### 10.2 Pat Morton Precinct - Concept Designs - Adoption

<b>Section</b>	Engineering Works
<b>Objective</b>	To report on the public exhibition of the Pat Morton Precinct Car Park and Shared Path Concept Designs and adopt a preferred design.

1. Pat Morton Precinct - Car Park and Shared Path Concept Design
2. Submissions (Under separate cover)

Shared Pathway - Pat Morton Lookout Precinct  
**OPTION 1: PLAN**  
 Sheet 10 of 17

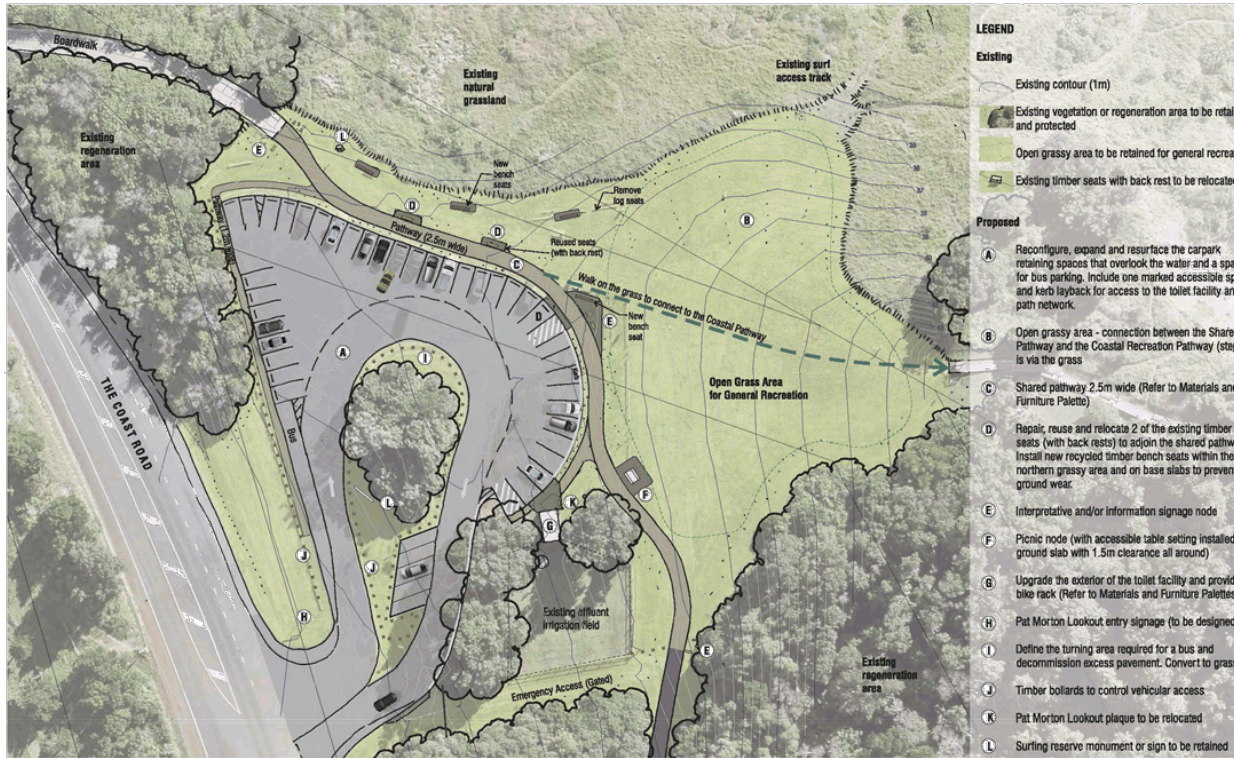
CONCEPT 1 is preferred for the following reasons:

- our iconic shared path is continued along the front of the lookout area making the walk/ride experience amazing
- The shared path is not made to cross the parking area
- Concept 1 will decommission 1 metre of unrequired bitumen and use it as a grass verge separating carpark and shared path
- Concept 1 provides a more efficient and freeflowing car parking layout. It involves only one (1) travel lane and all car parking spaces are accessible from the same travel lane
- Concept 1 maximises parking with 42 carspaces provided

CONCEPT 1 could be improved by :

a) Adding more than 1 picnic node. Concept 1 plan depicts only 1 Picnic node. Providing more opportunities for families and friends to create happy memories together at the lookout is a must.

c) Providing BIKE PARKING in a more visible area. Many people riding their bikes will want to park their bikes when they see the view yet the bike rack is proposed to be installed near the toilet. A good position would be in the area marked (E).

4) Option 1: The strip of planting between the car park & path would soften the hard surfaces but I am doubtful it would survive the foot traffic from the car park to the path and/or open space.

With such a wide spread of views, and a limited number of submissions, from a technical perspective, the preferred option is Option 1.

Options 1 and 2 avoid pedestrian and vehicle crossing points in the car park, and provide the most functional connection between the paths to the north and south, and to stairs to the top of the headland.

Option 1 is preferred to Option 2, as the grass strip between the car park and the path provides better visual amenity, albeit this will add a small amount of additional maintenance activities.

An alternative option instead of grass is a suitably coloured gravel, or stone mix, with some small native planting elements.

That Council adopts Option 1, from the concept designs attached to this report, as the preferred concept to support the detail design and delivery for the upgrade of the Pat Morton Car Park Precinct.

**OPTION 2: PLAN**

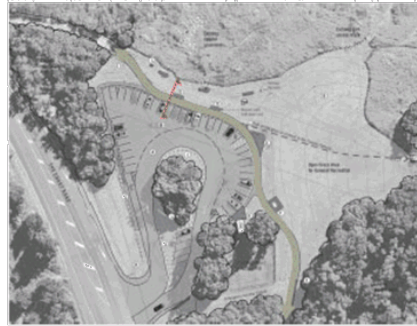
I would prefer Option 2. There is no point in running the path through the car park as it is extremely dangerous especially when there is a good surf on and the carpark is extremely busy.

CONCEPT 2 is not preferred as there is no space (grass verge) between car parking area and shared path. Having a grass verge between car park and shared path makes the interface between the two much safer and therefore easier to enjoy.

There is plenty of open green space for the community to enjoy in area (B) of the concept plan. We do not need to maximise greenspace to the extent that Concept 2 does, as it comes at a cost of safety. The verge / swale area will also help alleviate stormwater runoff from the carpark into the natural environment.

I would like to express my preference for Option 2.

I prefer this option overall as it creates an uninterrupted flow for pedestrians and cyclists and is thus safer and more relaxing for all users , especially families with children.

I also prefer the optimal preservation of grassy area on the northern side.
